# UNITED STATES PATENT AND TRADEMARK OFFICE

10/785,209

<b>Office Action Summary</b>	<b>Application No.</b> 10/785,209	<b>Applicant(s)</b> HOHMANN, RONALD P.	
	<b>Examiner</b> Adriana Figueroa	<b>Art Unit</b> 3633

## **DETAILED ACTION**

Hohmann (US 4,598,518)

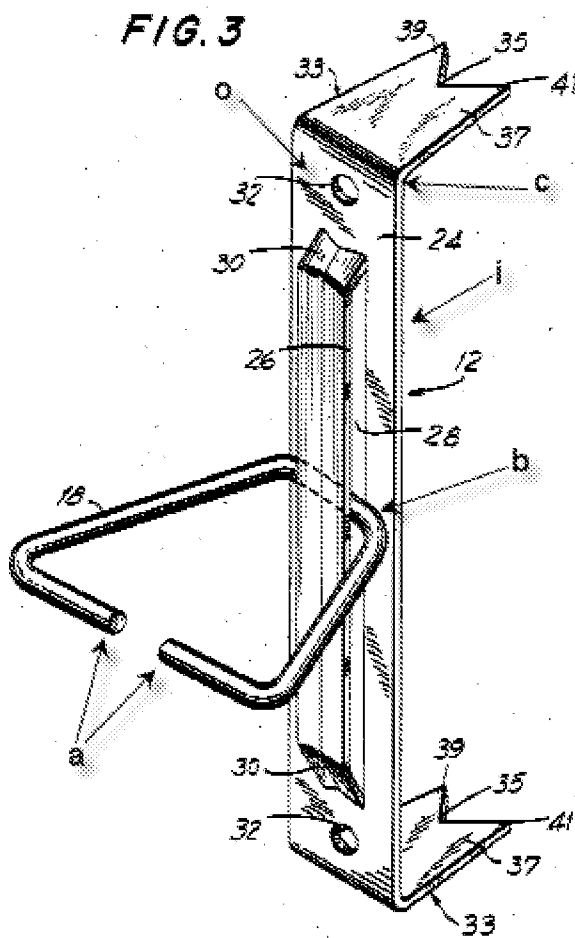
said outer wythe formed from a plurality of successive courses (22) with a bed joint between each two adjacent courses, said inner wythe and said outer wythe in a spaced apart relationship the one with the other forming a cavity therebetween, said inner wythe having an exterior layer being insulation (17), (Figures 1, 2), said surface-mounted anchoring system comprising: an anchoring system having a wall anchor (12) constructed from a plate-like body (24) having two major faces being the mounting surface (i) and the outer surface (o), said wall anchor, in turn, comprising: a pair of legs (33), each extending from said mounting surface of said plate-like body from an inboard location thereof with the longitudinal axis of each of said legs being substantially normal to said mounting surface (i), (annotated Figure 3), said legs adapted for insertion at a predetermined insertion point into said exterior layer of said inner wythe,

a covering portion (c) formed at said mounting surface (i) of said plate-like body, said covering portion adapted to preclude penetration of air, moisture and water vapor into said exterior layer, (annotated Figure 3);

an apertured receptor portion (28) adjacent said outer surface (o) of said plate-like body (24), (annotated Figure 3), said aperture receptor portion adapted to limit displacement of said outer wythe toward and away from said inner wythe;

a veneer tie (18) threadedly disposed through said apertured receptor portion (28), (annotated Figure 3) of said wall anchor and adapted for embedment in said bed joint of said outer wythe to prevent disengagement from said anchoring system.

Regarding claim 7, Hohmann modified by Stephens discloses the claimed invention; Hohmann further teaches said veneer tie further comprises an anchoring system having reinforcement wire (18); an attachment portion (a) for threading through said apertured receptors (28); an insertion portion (b) contiguous with and opposite said attachment portion, said insertion portion being swaged for interconnection with said reinforcement wire, (annotated Figure 3);
